Re: **COMBINED STORMWATER
MANAGEMENT CONCEPT/SITE
DEVELOPMENT STORMWATER
MANAGEMENT PLAN** for
Iglesia De Cristo Mi El MD
SM File #: 285406
MNCP&PC Process/No: 120200200
Tract Size/Zone: 7.17 ac.
Total Concept Area: 5.06 ac.
Parcel(s): 950
Watershed: Hawlings River

RE: Preliminary Plan No. 120220040
Iglesia De Cristo Mi El Maryland

DATE: 26-Oct-25
TO: Mike Razavi
Raztec Associates Inc.
FROM: Marie LaBaw
RE: Iglesia De Cristo Mi El Maryland
120220040

FIRE TRUCK ACCESS EXHIBIT

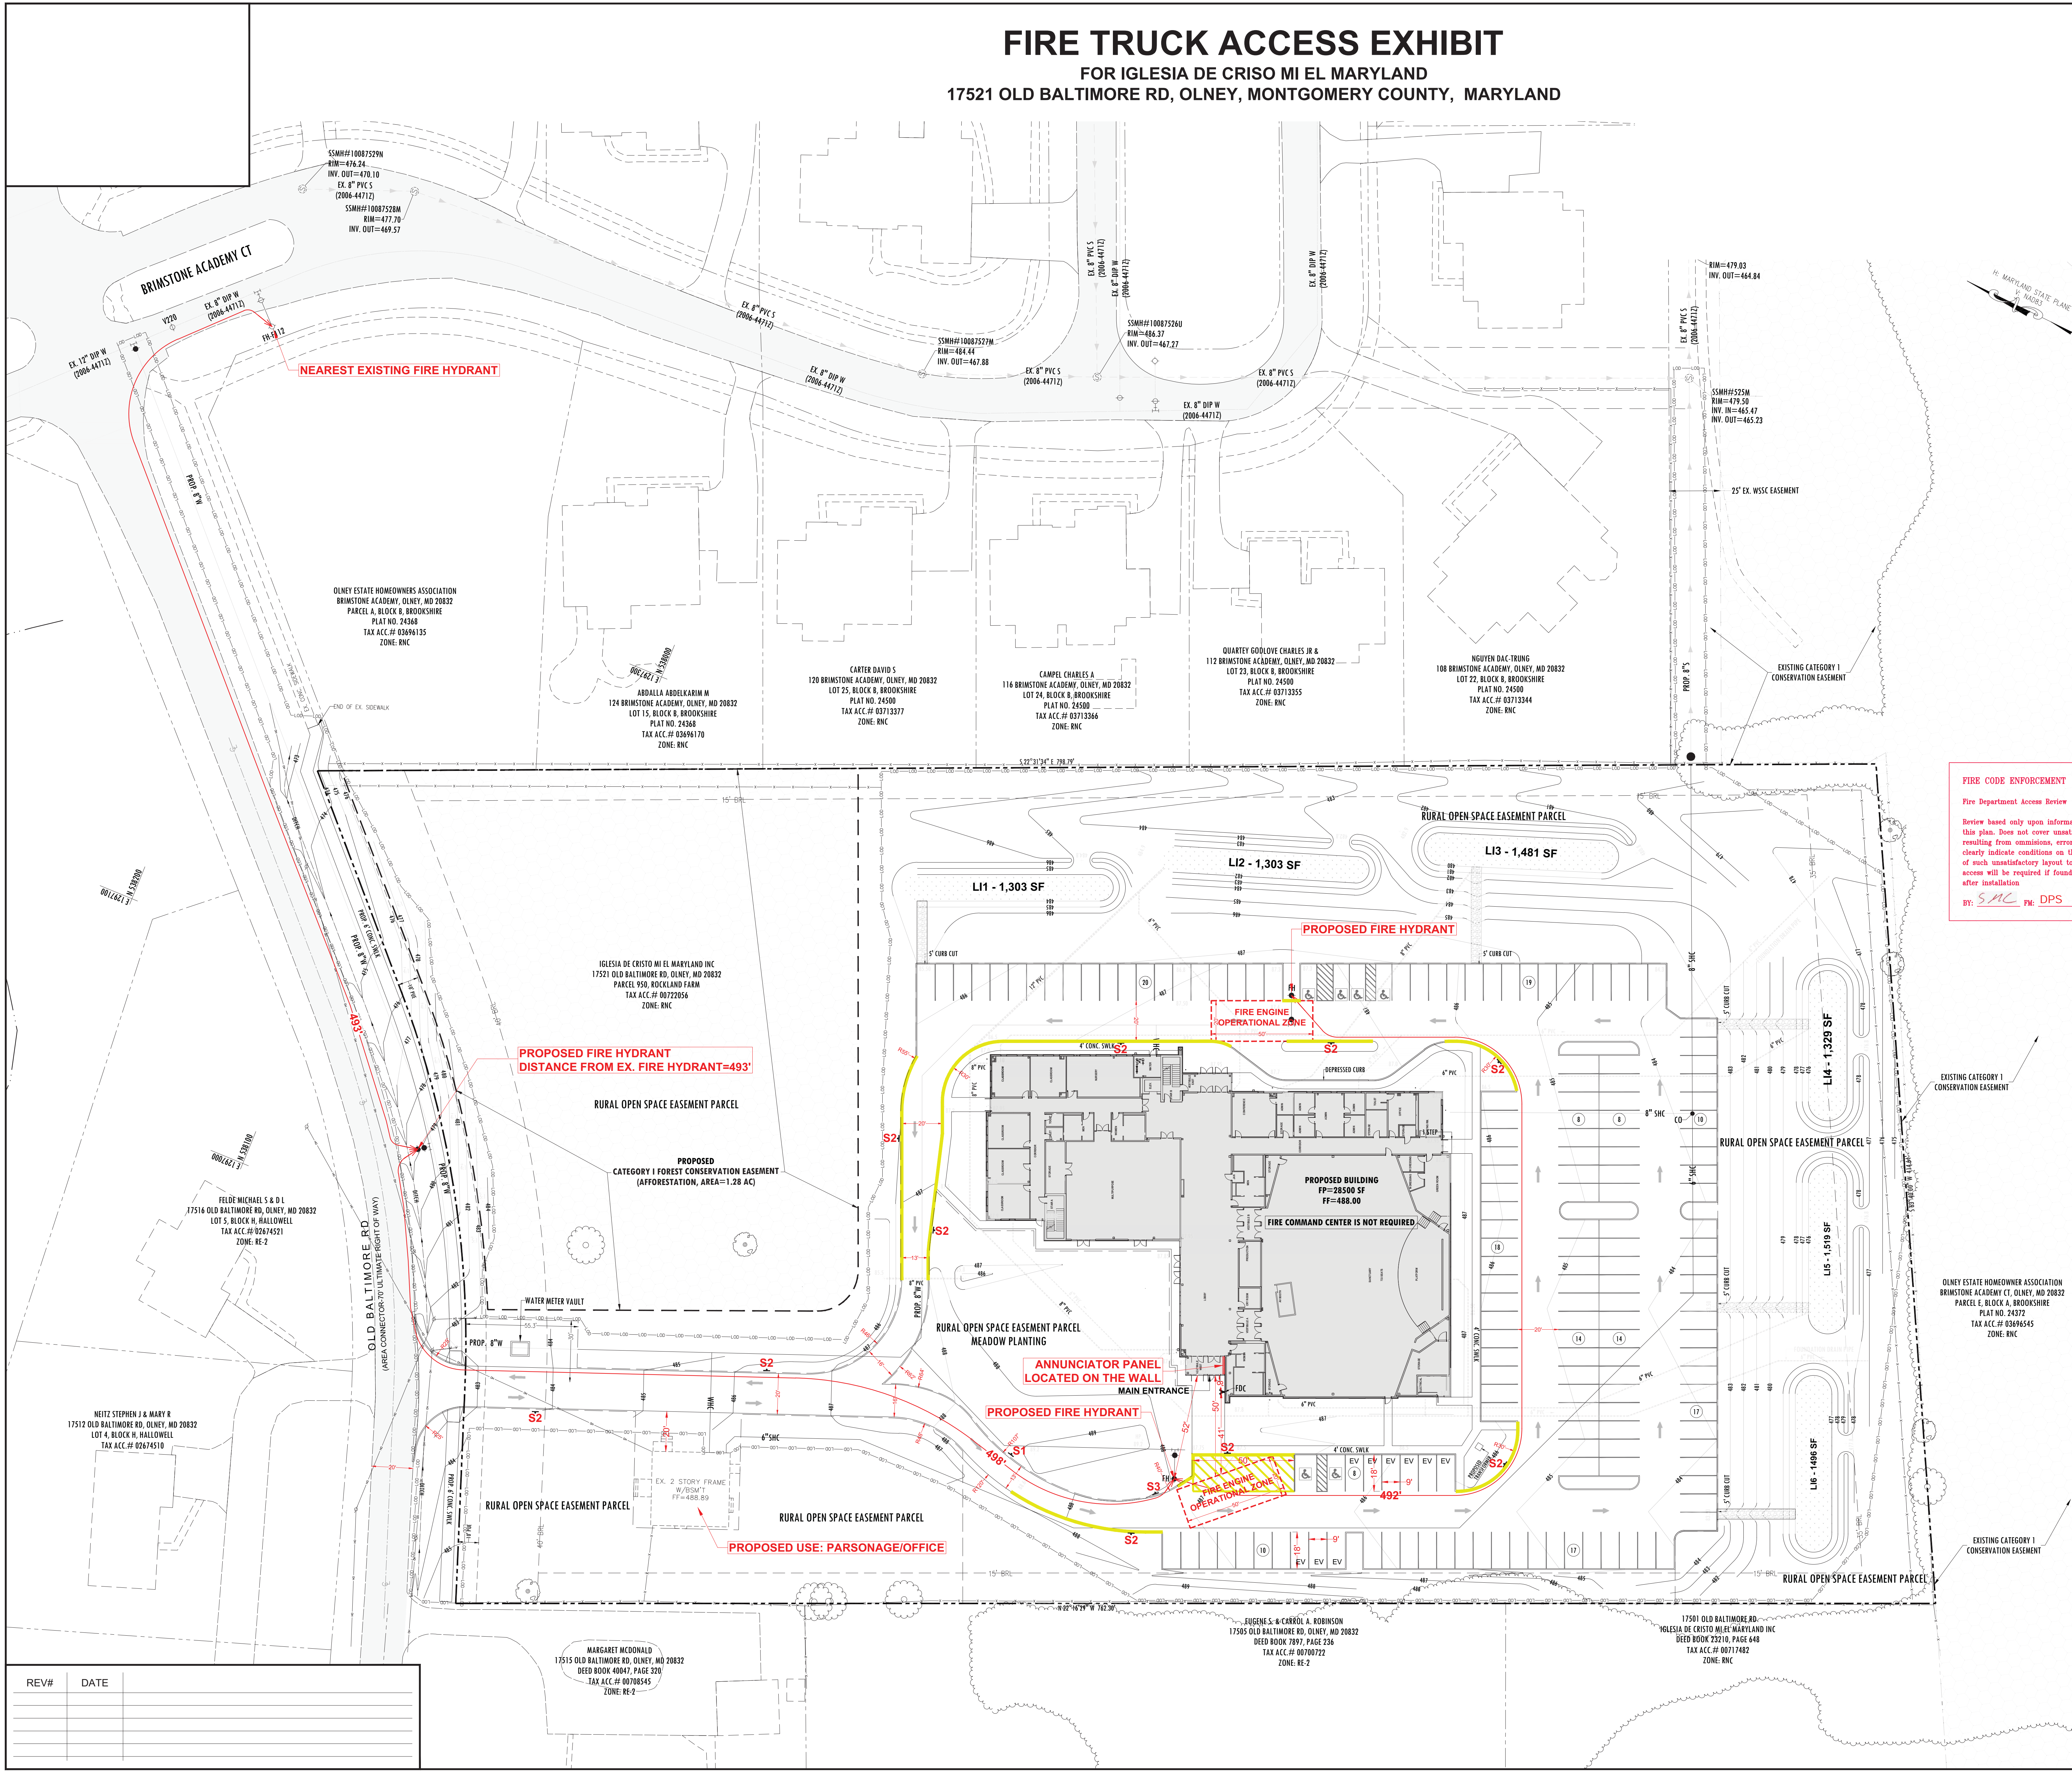
Re: Iglesia De Cristo Mi El MD-Performance Based Design Option

We are providing the required twenty-foot (20') driveway ingress entrance, at Old Baltimore Road into the proposed site, with the required radii based on calculations provided. The driveway will remain twenty feet (20') for approximately 190 feet, starting at the property line and travelling in an easterly direction, where the driveway turns to one way traffic and the pavement is reduced to 16' to 13' wide. Based on calculations provided the radii exceed the requirements for fire and emergency vehicles. The proposed fire hydrant will be within two feet of the edge of pavement.

At the exit point on the westerly side of the proposed building the one way exit drive will reduce from 20 feet to 13'-16', and as calculated provide adequate radii to accommodate the fire truck and emergency vehicles.

We believe the reduced paving 13'-16' pavement will provide adequate fire and rescue access for one-way directional traffic in this part of the site. The proposed access width will be in excess of the fire truck width. Location of pavement narrowing are not in critical areas for building service.

The proposed access driveway will be constructed to a traditional paved load bearing pavement, to support fire trucks and other emergency vehicles. Since this portion of the driveway is designed to be one-directional, there will be no requirement for a passing zone. Also, there will be no obstacles or other on-coming traffic.

Furthermore, operational access of 20' x 50' is provided near the main access point to the building, and at one other locations on the north side of the building where there is a

proposed drop-off area. In both these locations, the required 20 feet wide pavement is provided. A fire hydrant is provided adjacent to the operational zones.

A FDC connection is provided 41' from the proposed operational zone, close to the main entrance, and within walking sight of the fire personnel. The stopping point of the fire truck is 50' from the front access of the building. All radii at intersections and other turns have been calculated throughout the site and adequately meet the turning template of the fire truck, as presented on the proposed Fire Department Access Plan. Therefore, the fire truck can be driven throughout the site without being hindered.

PLAN APPROVED
